# Access Compliance Report

## Public Rights-of-Way

Intersection ID: 17504	Main Street: CORINTHIAN_PL	Cross Street: WALKER_RD	Location: NE
ADA ID: 01CB4FB632FC	Ramp Type: PerpDiag	Initial Pass/Fail: Fail	Overall Compliance: No
Codes/Mitigation Info/Possible Solution		Field Measurements/Component Compliance

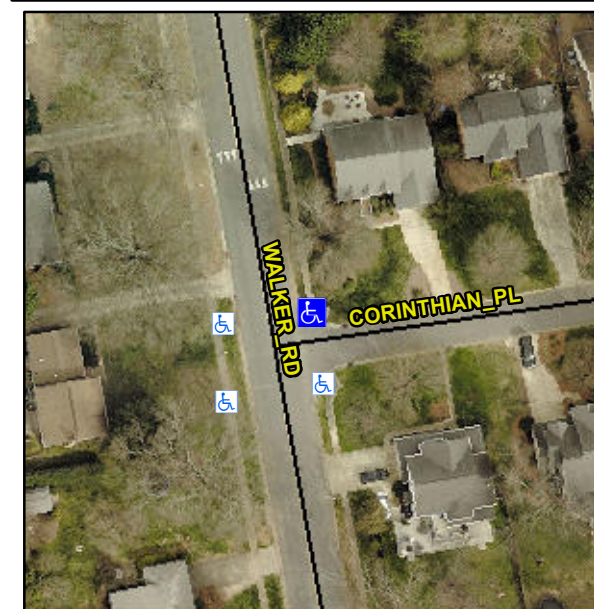
**Not Found, R304.5.1, R304.2.2, R304.5.3**

Compliance	Description	Data	Compliance	Description	Data
N/A	Ramp Length (in)	48.0	No	Ramp Slope (%)	9.2
No	Ramp Width (in)	30.0	No	Ramp XSlope (%)	4.5
N/A	Flare Type LT	N/A	N/A	Flare Type RT	N/A
N/A	Flare Slope LT (%)	N/A	N/A	Flare Slope RT (%)	N/A
N/A	Flare Traversable LT?	N/A	N/A	Flare Traversable RT?	N/A
N/A	Landing Length (in)	N/A	N/A	DWS Provided?	N/A
N/A	Landing Width (in)	N/A	N/A	DWS Contrast?	N/A
N/A	Landing Slope (%)	N/A	N/A	DWS Length (in)	N/A
N/A	Landing X Slope (%)	N/A	N/A	DWS Full Width?	N/A
N/A	Landing Curb? (Y/N)	N/A	N/A	DWS Offset (in)	N/A
N/A	Shared Landing?	N/A			
N/A	Gutter Ponding?	N/A	N/A	Gutter Slope (%)	N/A
N/A	Gutter Lip Ht (in)	N/A	N/A	Gutter X Slope (%)	N/A
N/A	Painted X Walk1?	No	N/A	Painted X Walk2?	No
	X Walk 1 Direction	To W		X Walk 2 Direction	To S
N/A	X Walk 1 Width (in)	N/A	N/A	X Walk 2 Width (in)	N/A
	X Walk 1 Slope (%)	7.6		X Walk 2 Slope (%)	2.3
	X Walk 1 X Slope (%)	2.8		X Walk 2 X Slope (%)	5.1

N/A	Ramp inside XWalk1?	N/A	N/A	Ramp inside XWalk2?	N/A
	Road Slope (%)	2.2	N/A	Clear Space?	N/A
	Road X Slope (%)	6.9	N/A	Clear Space to XWalk (in)	N/A
N/A	Any Obstructions?	N/A	N/A	Storm Grate/Utility Hazard?	N/A
	Obstruction Type			Storm Grate/Utility Type	
		N/A			N/A
			Yes	Surface Condition? (G/P)	Good

**Remove & Replace Curb Ramp With Two New Directional Ramps or Equivalent.**
